LANDSCAPE PEER REVIEW

Bayswater Vehicles Ltd

Prepared for
Napier City Council
By Development Nous Limited

21 June 2021 – REVISION A

Figure 1 – scale comparison earthworks vs. built form.

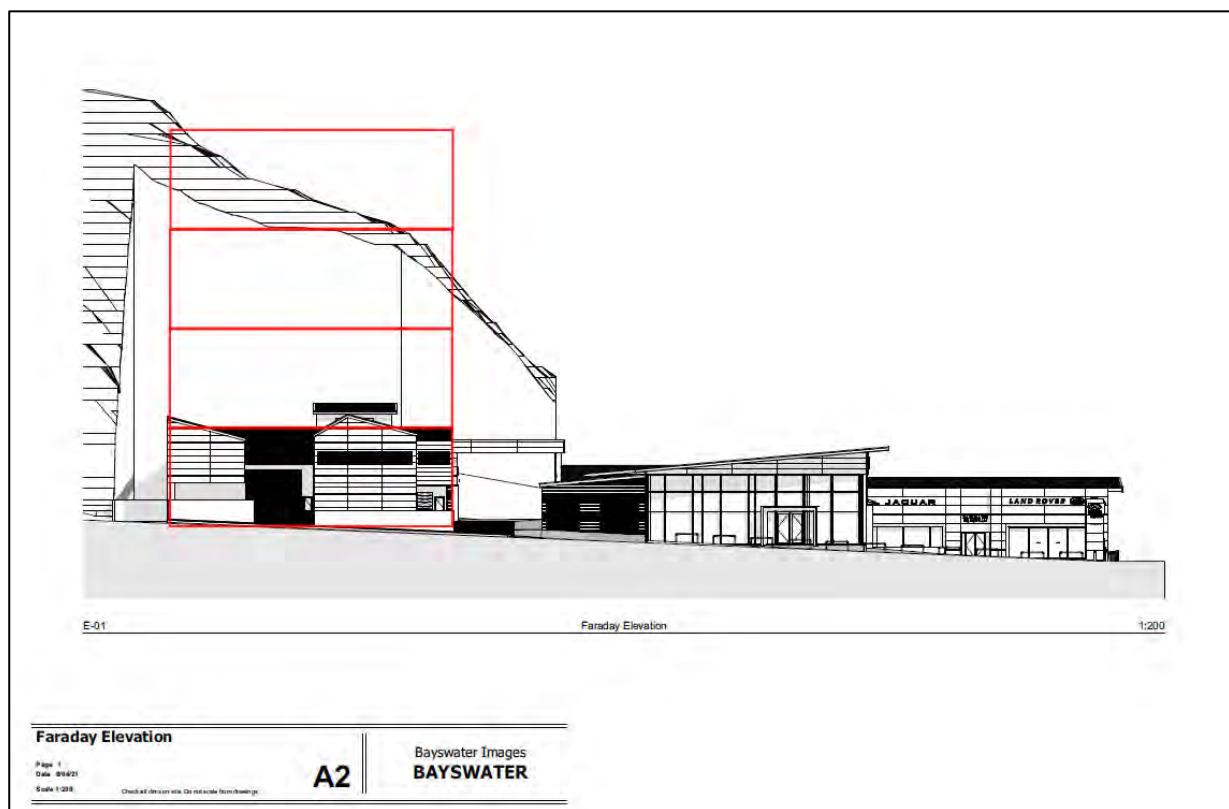
It may be true that the proposed earthworks will be partially mitigated by the existing and proposed built form, however the overall extent of cut is 2 ½ - 3 times larger in scale. See below earthworks and built form comparison diagrams.

Figure 3 – scale comparison earthworks vs. built form.

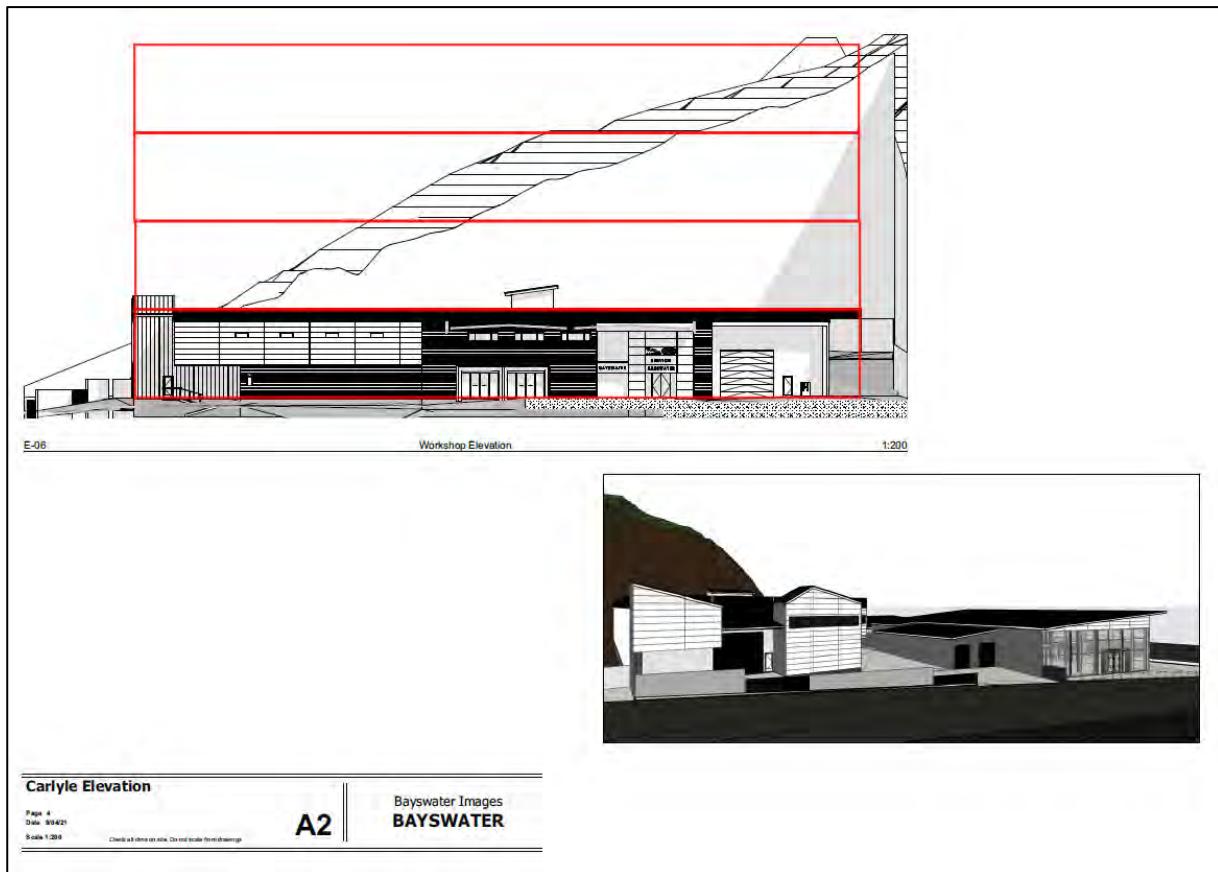
The LVA also considers that “the change in slope face is not unexpected or dissimilar to the nature of the Mataruahou slope”. I disagree with this finding given the proposed earthworks imposes an unnatural cut, with an almost vertical sheer face and cut terraced benching. The LVA goes on to state that the area can visually absorb the proposed earthworks through mitigation. However, it is the existing vegetation on the face of the hill that creates the visual absorption, removal of the vegetation decreases visual absorption capacity creating a higher visual effect, hence the need for better clarification around mitigation measures, methods and duration of the temporary effect.

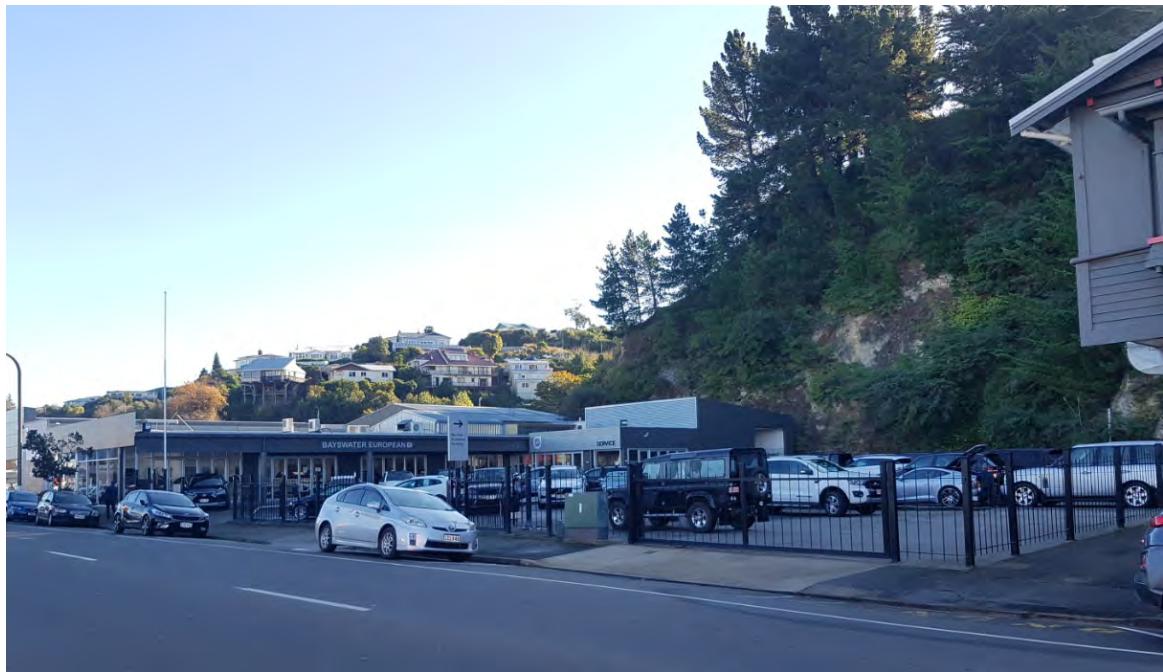
Figure 29 - View from 110 Carlyle Street of site – smaller wilding pines on bottom of slope will be the base of the earthworks cut as well as smaller cut to visible face for new building to be located in foreground of yard. Large pines will likely be removed due to instability. Scale of proposed building will obscure half the height of the cut on this face.
